## Proposal for amendments to Regulation No. 13 (Heavy vehicle braking)

The text reproduced below was prepared by the experts of the informal working group ACV to be inserted into Regulation No. 13. This is to produce:

**Figure A: Point-to-point connection ECU Tractor (1) and ECU Trailer (9) when Fifth Wheel is closed**

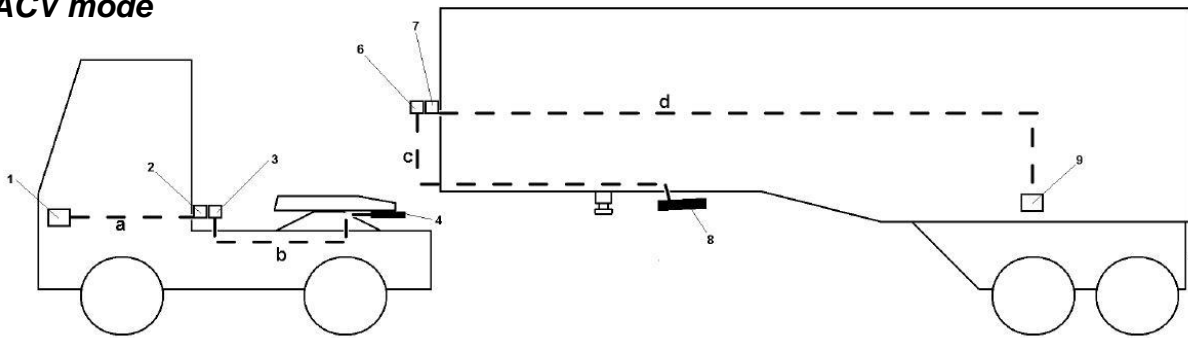
The active connection shall not have any bypasses or dead ends. (For example see Annex 21, Figure A to D) {Figure 4 ISO7638}

**ACV mode: No helix cables installed, Connection between 3 and 6 when 4 and 8 are connected (i.e. fifth wheel coupled)**

**Figure B: Point-to-point connection ECU Tractor (1) and ECU Trailer (9) when Fifth Wheel is closed**

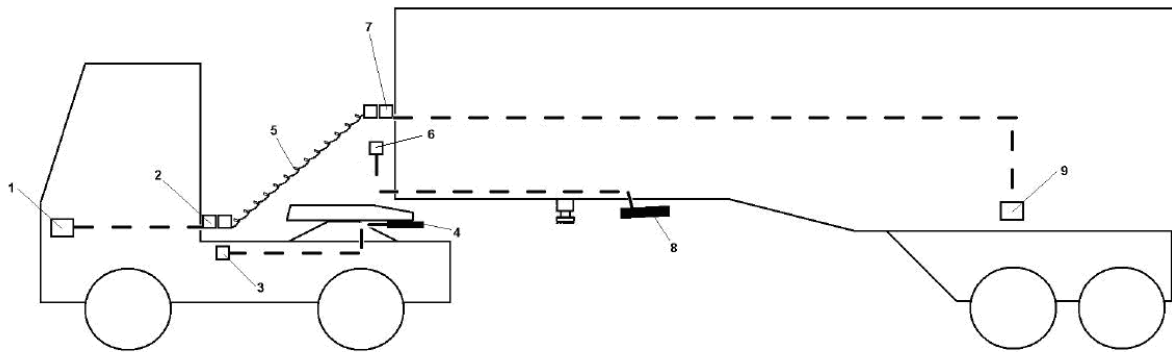
**Manual mode: Helix cables installed, Connection between 3 and 6 as 4 and 8 are not connected**

**Figure C: Point-to-point connection ECU Tractor (1) and ECU Trailer (9) when Fifth Wheel is closed  
Helix cables installed, Line 3 to 4 is not connected**

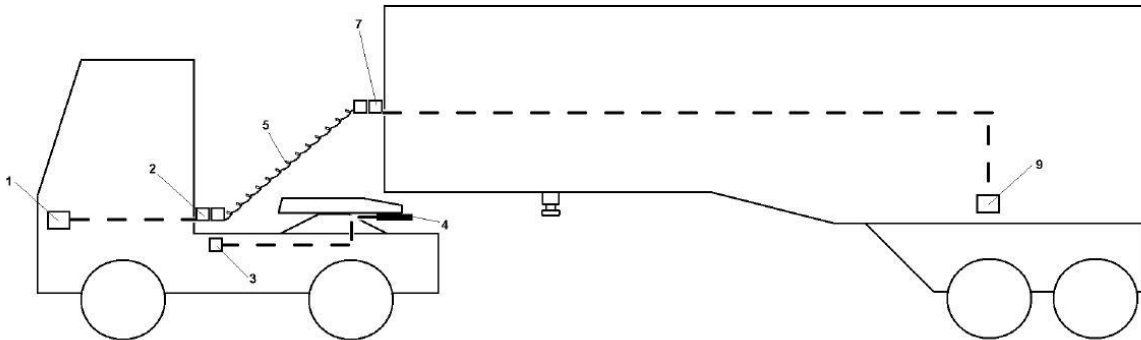
**Manual mode A (only the truck ACV equipped)**

**Figure D: Point-to-point connection ECU Tractor (1) and ECU Trailer (9) when Fifth Wheel is closed  
Helix cables installed, Line 6 to 8 is not connected**

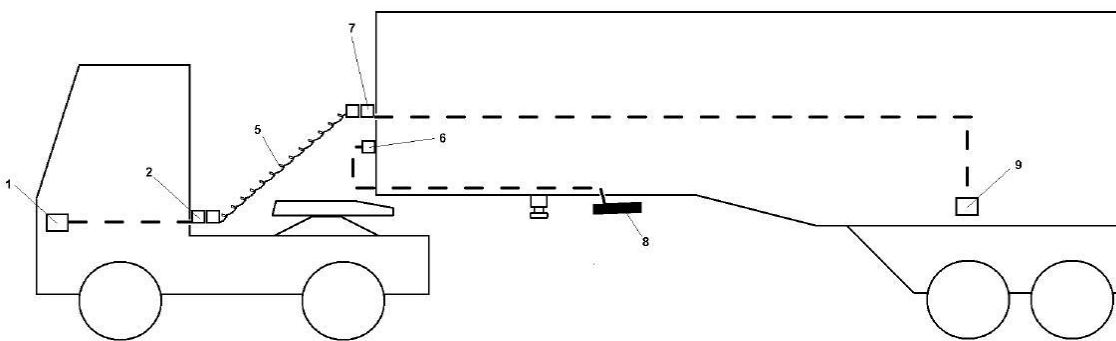
**Manual mode B (only the trailer ACV equipped)**
